**RE: 16-10 Wastewater Facility & Collection System Master Plan – DEQ Revision's**

RE: City of Molalla STP  
File No: 57613/Permit No. 101514  
Clackamas County

**Returned for Corrections – Draft Facility Plan**

**WASTEWATER FACILITY AND COLLECTION  
SYSTEM MASTER PLAN  
VOLUME 1**

**FIGURE 3.1.2  
HISTORICAL EFFLUENT FLOWS OUTFALL 001 (2016 – 2017)**

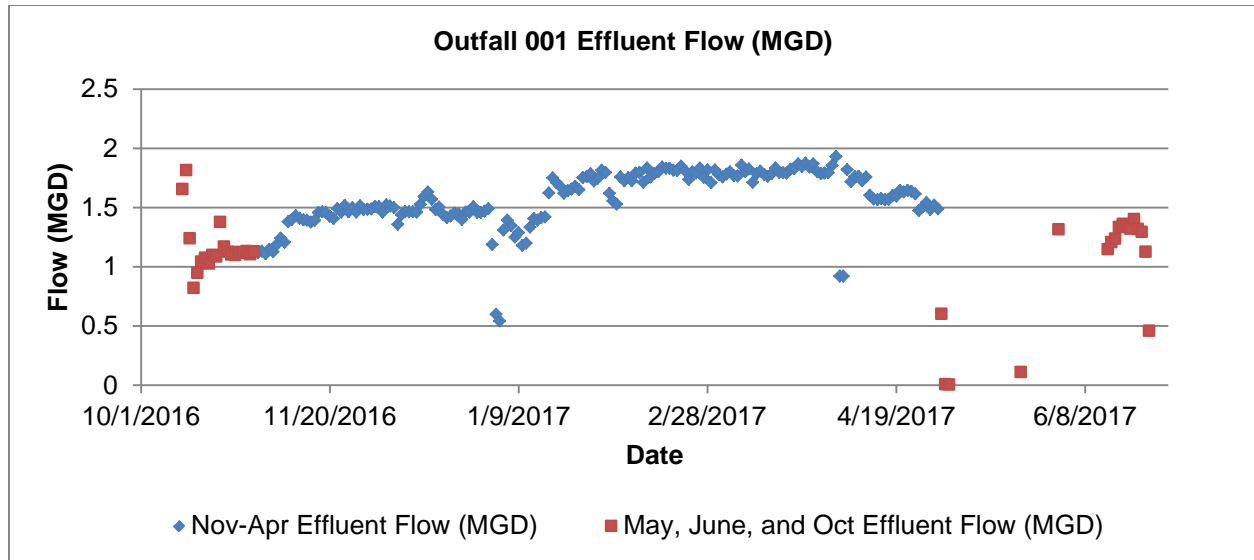
4. Page 3-12, Figure 3.1.2 HISTORICAL EFFLUENT FLOWS OUTFALL 001 (2016-2017): These values are not corrected for the flow measurement calculation error discovered in March 2018.

4. ***Page 3-12, Figure 3.1.2 HISTORICAL EFFLUENT FLOWS OUTFALL 001 (2016-2017): These values are not corrected for the flow measurement calculation error discovered in March 2018.***

RESPONSE: Due to the City of Molalla's recent discovery and subsequent DMR corrections, various parts of the WWFCSMP were updated. Following is a summary of content updated, all to take into account the revised flow data;

RESPONSE: Updated, refer to response number three above.

**FIGURE 3.1.4  
HISTORICAL WWTP EFFLUENT MONTHLY BOD<sub>5</sub> MASS LOAD (LBS/DAY)**

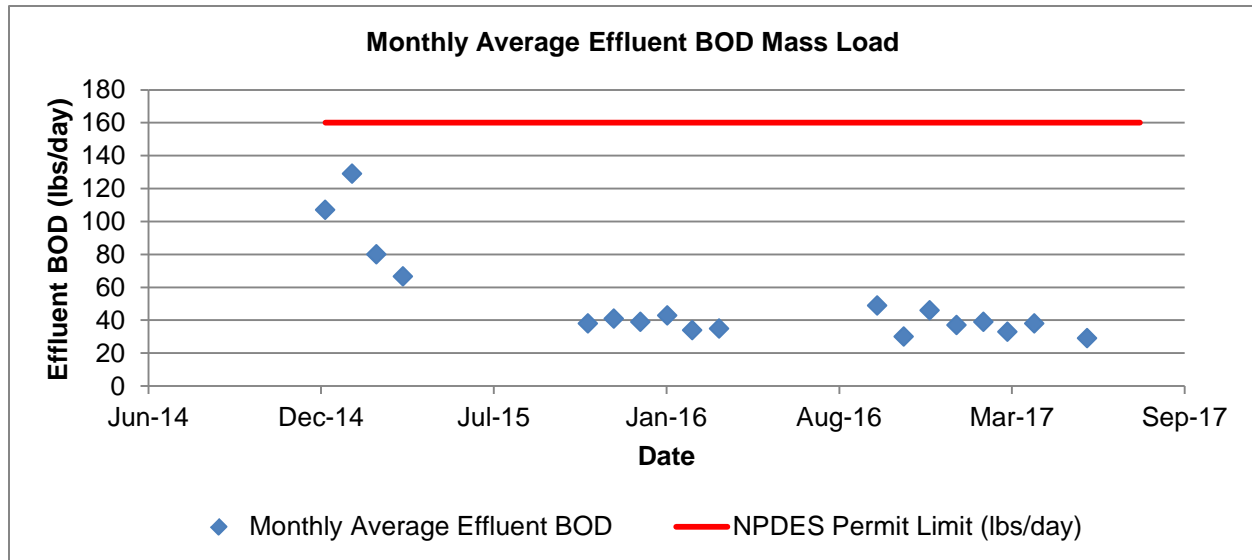
5. Page 3-13, Figure 3.1.4 HISTORICAL EFFLUENT bod MONTHLY MASS LOAD (2016-2017): These values are not corrected for the flow measurement calculation error discovered in March 2018.

5. ***Page 3-13, Figure 3.1.4 HISTORICAL EFFLUENT BOD MONTHLY MASS LOAD (2016-2017): These values are not corrected for the flow measurement calculation error discovered in March 2018.***

RESPONSE: Updated, refer to response number three above.

**FIGURE 3.1.6  
HISTORICAL WWTP EFFLUENT MONTHLY TSS MASS LOAD (LBS/DAY)**

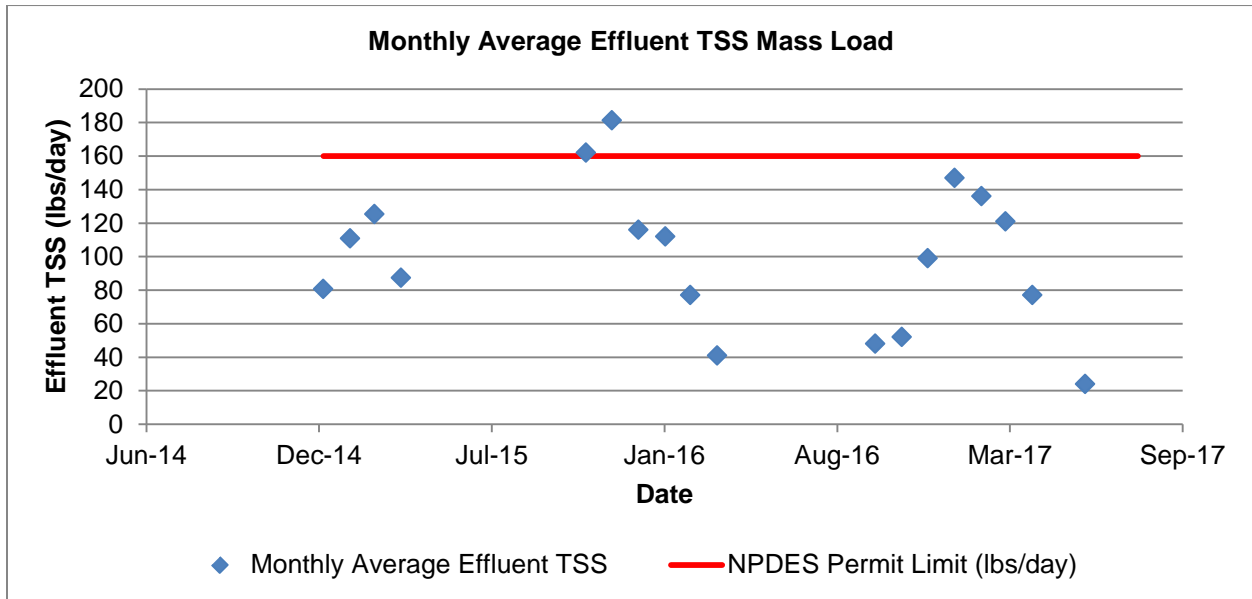
6. Page 3-14, Figure 3.1.6 HISTORICAL EFFLUENT TSS MONTHLY MASS LOAD (2016-2017): These values are not corrected for the flow measurement calculation error discovered in March 2018.

6. ***Page 3-14, Figure 3.1.6 HISTORICAL EFFLUENT TSS MONTHLY MASS LOAD (2016-2017): These values are not corrected for the flow measurement calculation error discovered in March 2018.***

RESPONSE: Updated, see response to number three above.

**FIGURE 3.3.2  
WWTP HISTORICAL FLOWS (2014 – 2017)<sup>1</sup>**

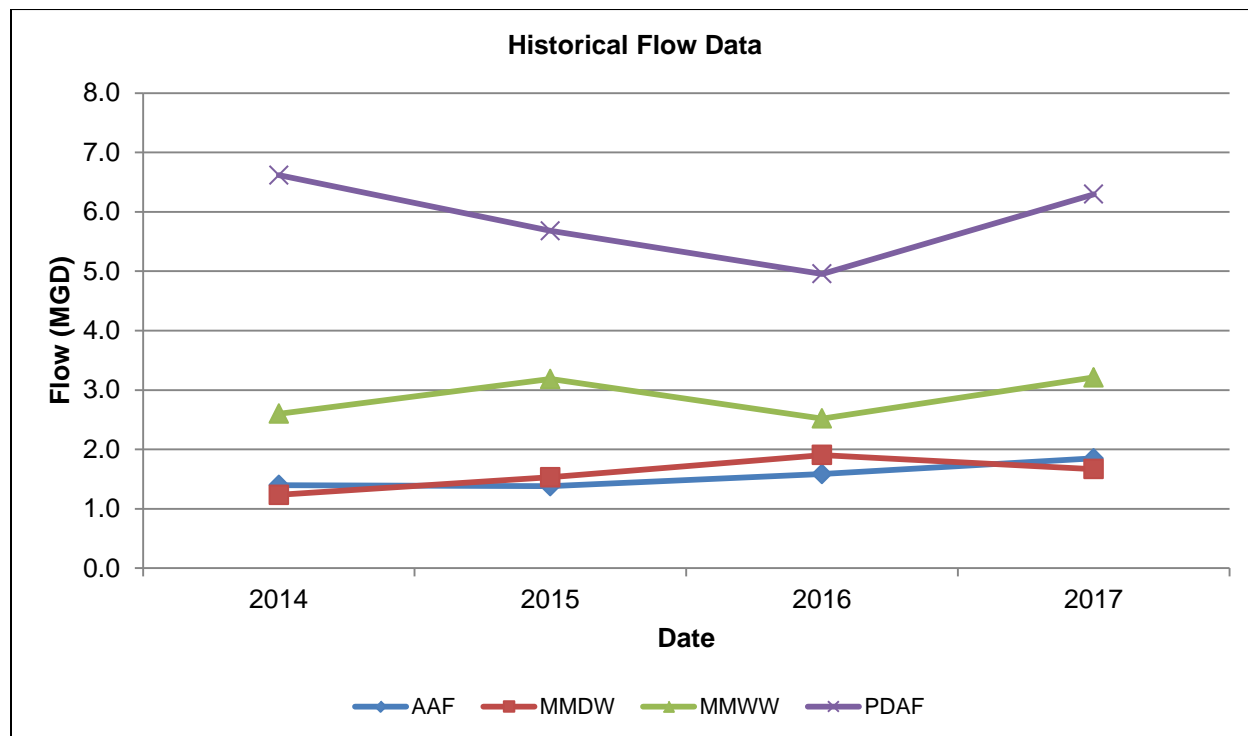
7. Page 3-24, Figure 3.1.6 WWTP HISTORICAL FLOWS (2014-2017): Label this figure as influent or effluent flows. If these are effluent flows, use the corrected calculations for flow data.

7. ***Page 3-24, Figure 3.1.6 WWTP HISTORICAL FLOWS (2014-2017): Label this figure as influent or effluent flows. If these are effluent flows, use the corrected calculations for flow data.***

RESPONSE: Updated, refer to response number three above.

**FIGURE 3.4.5  
RAINFALL STORM EVENT VERSUS PLANT INFLOW**

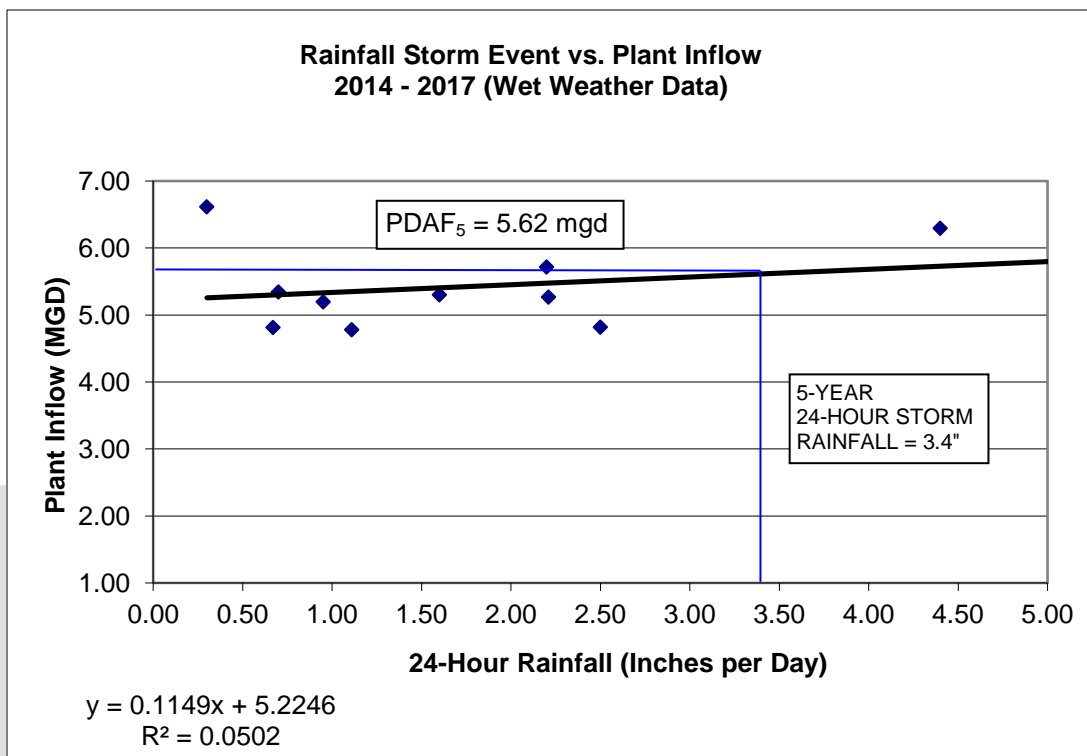
10. Page 3-33 Figure 3.4.5 RAINFALL STORM EVENT VERSUS PLANT INFLOW: This graph shows that infiltration is a serious problem need in to be addressed in Molalla.

- 10. Page 3-33 Figure 3.4.5 RAINFALL STORM EVENT VERSUS PLANT INFLOW: This graph shows that infiltration is a serious problem need in to be addressed in Molalla.**

RESPONSE: Noted.
